# System Impact Assessment Report

**Project: Toyota TS**

**Applicant: Hydro One Networks Inc.**

*CAA ID 2006-225*

Figure 2. Toyota TS Single Line Diagram

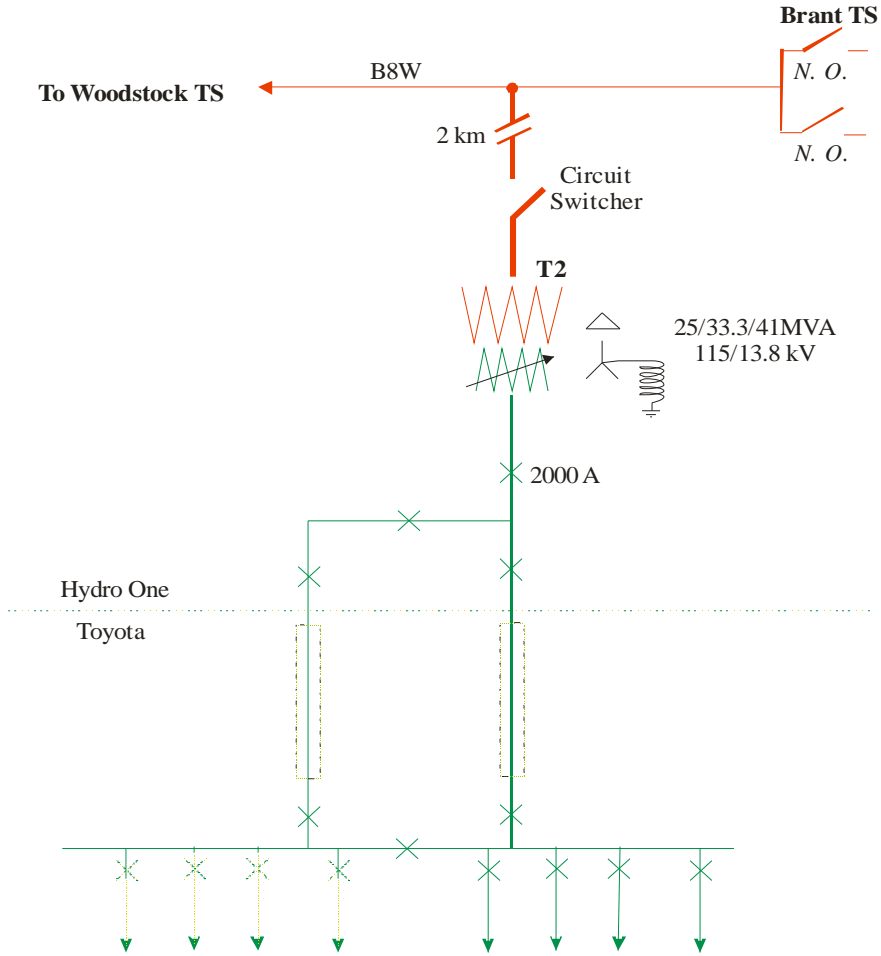
requirement an under frequency load shedding (UFLS) scheme must be installed at the station. The single line diagram does not show the presence of the UFLS scheme.

The Connection Applicant is required to commit that UFLS will be installed at the station to meet the Market Rules requirements.

**Figure 5. Voltage on 115 kV buses at Woodstock TS (May 29 – June 4, 2006)**

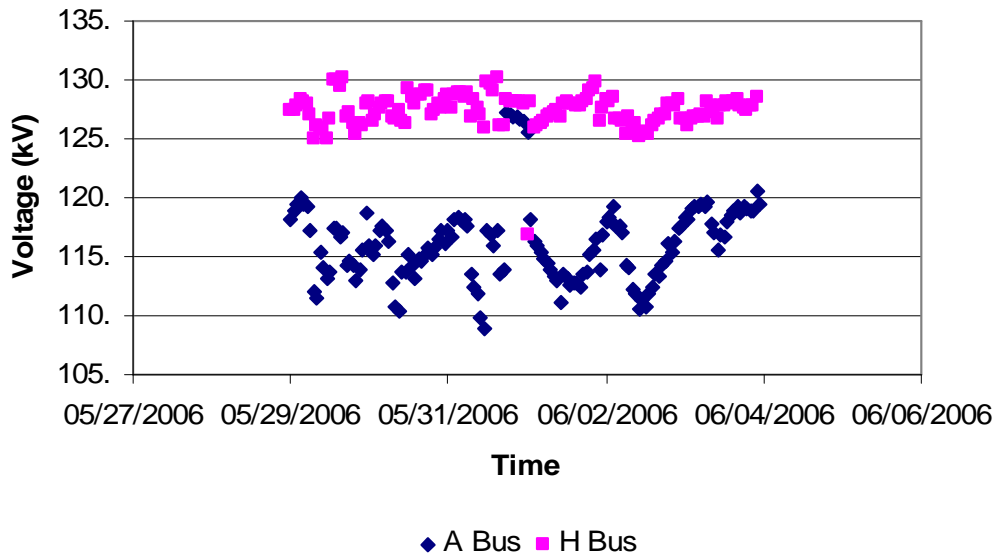
It can be seen from Figure 5 that the voltage was as low as 108 kV when W7W was not in service, which barely met the IESO's criteria.

**Figure 6. Voltage changes on LV bus at Woodstock TS (Aug. 01, 2006)**

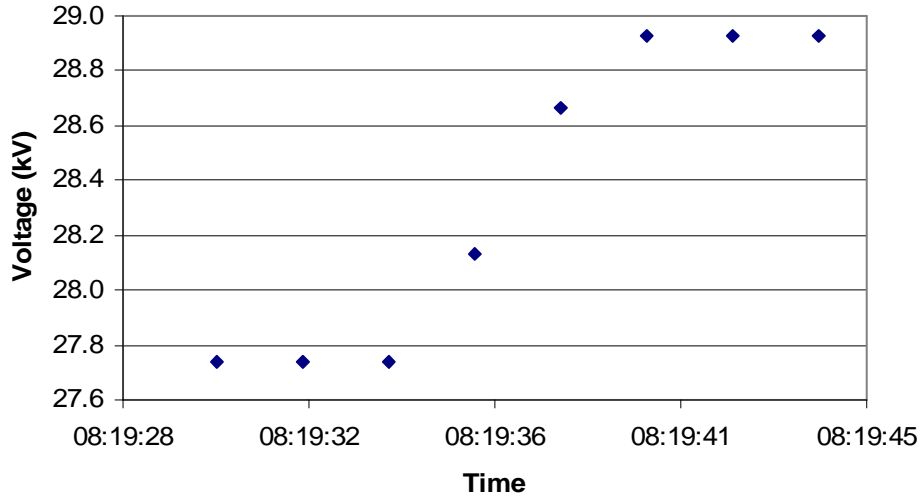
As shown in Table 5, the HV busses at Woodstock TS exhibit voltage changes less than 4% which meets Market Rules requirements. However, similar with the operating records shown in Figure 6, the simulated LV bus has voltage changes greater than 4%.
